RE: Construction Inspection – 1408 NE Ernest Way

We are in receipt of recent framing inspection comments for the referenced project and have the following responses.

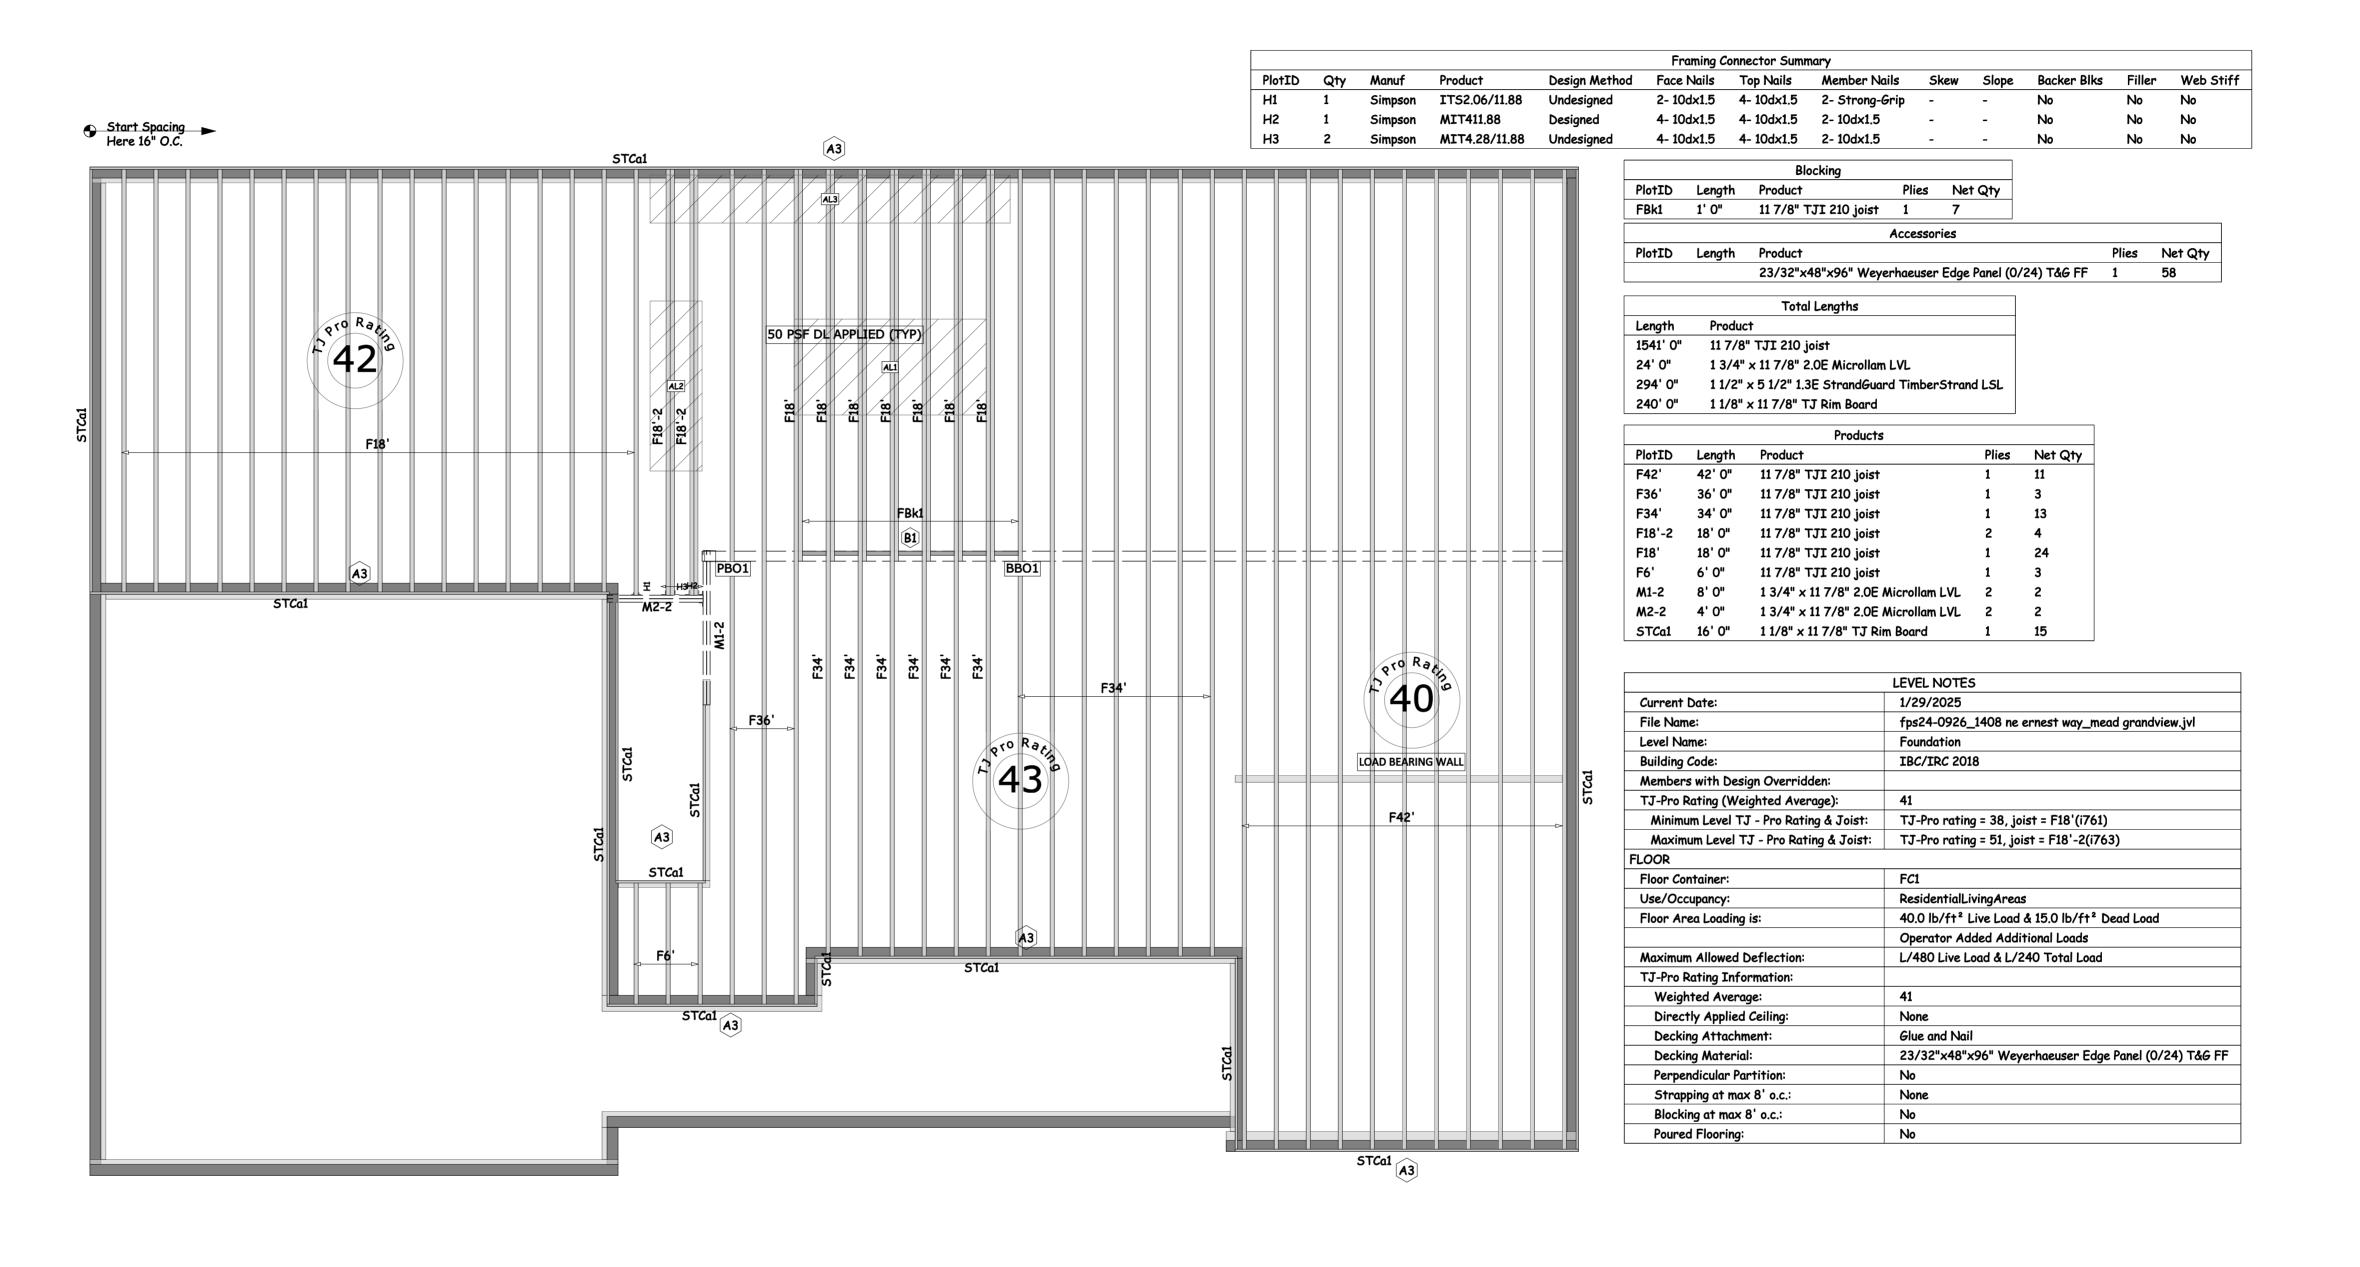
This will be addressed in the field.
- 3. "Fb wall space vertically at maximum ten ft intervals \*\*fb as discussed" This will be addressed in the field.
- 4. "I joist plan shows M1-3 beam above front basement bedroom. Have the plan revised and approved by the floor joist engineer"

The I-joist plan has been revised to delete the beam M1-3 and replace with a bearing wall. (attached)
- 5. "Engineer address for cut off of TJI joist top flanges below master shower \*\*Revise plan to denote all bearing walls in basement"
